# Roadway Plans\_V1.pdf Markup Summary

# CONSTRUCTION PLANS

CLEARWAY FILING NO. 2, LOT 5		TITLE SHEET	
PROJECT NO. 44-042A		DATE: 06-02-2022	
DESIGNED BY: DIM		SCALE: HORIZONTAL: N/A	
DRAWN BY: CLP		VERTICAL: N/A	
CHECKED BY: DIM		SHEET 1 OF 15	
TS01

**STORM 4  
 STA 1+00.00 TO STA 2+47.36**

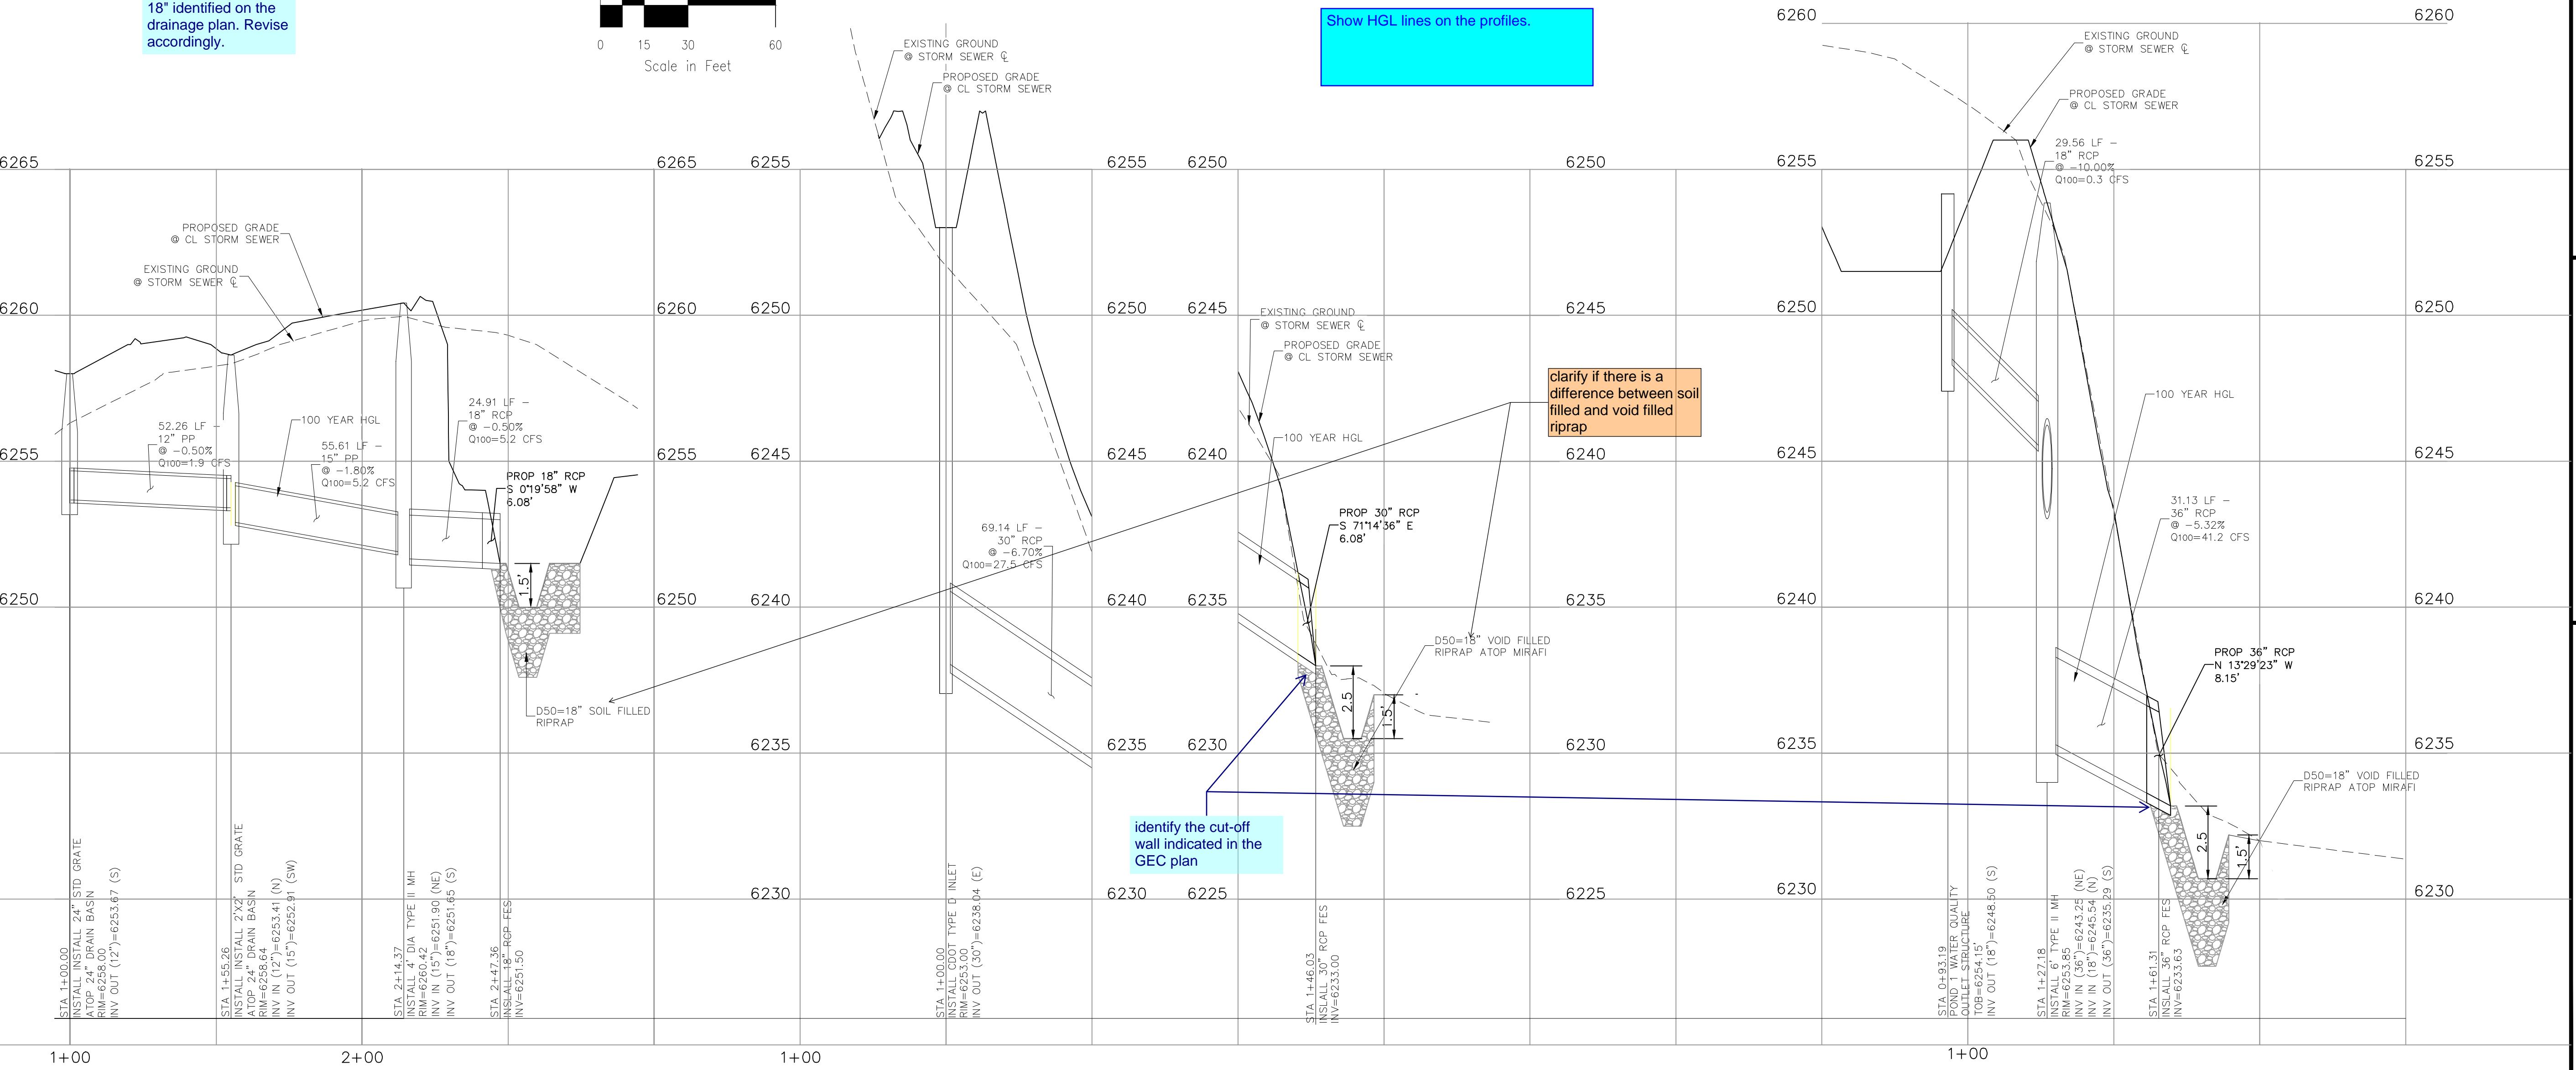
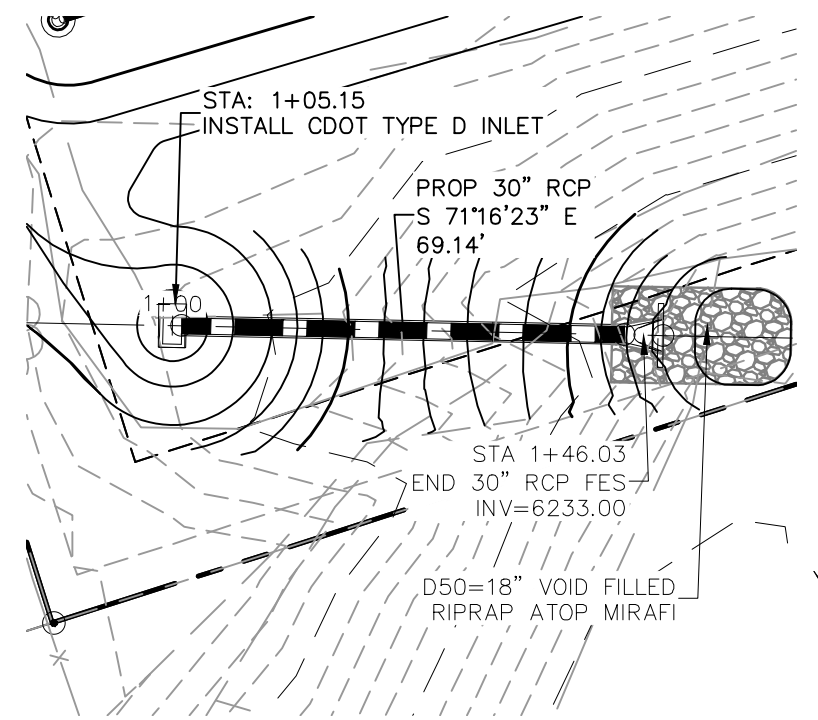
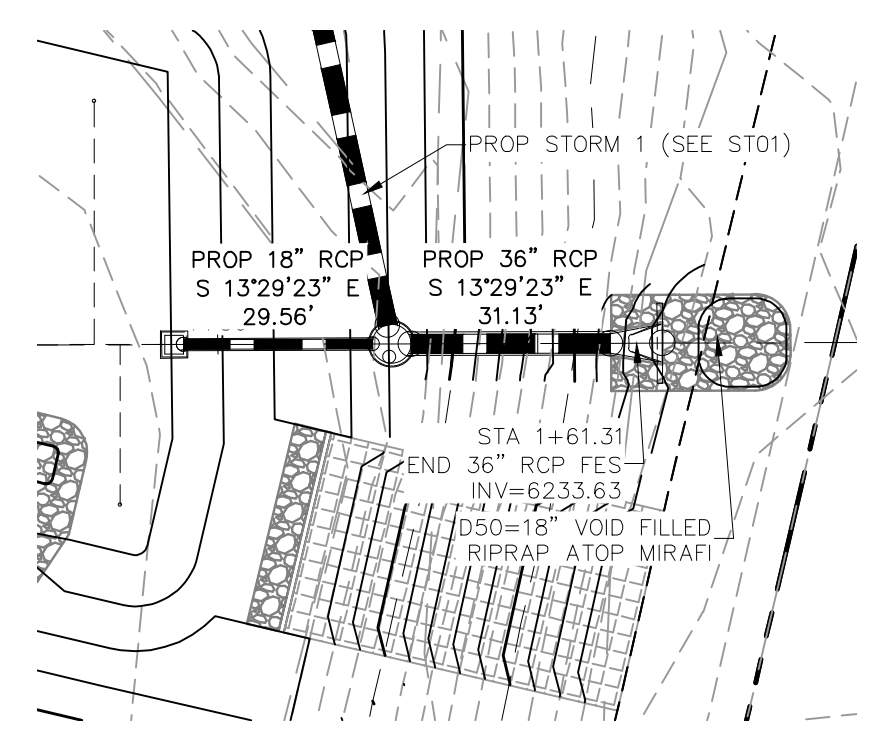
18" identified on the drainage plan. Revise accordingly.

Show HGL lines on the profiles.

clarify if there is a difference between soil filled and void filled riprap

identify the cut-off wall indicated in the GEC plan
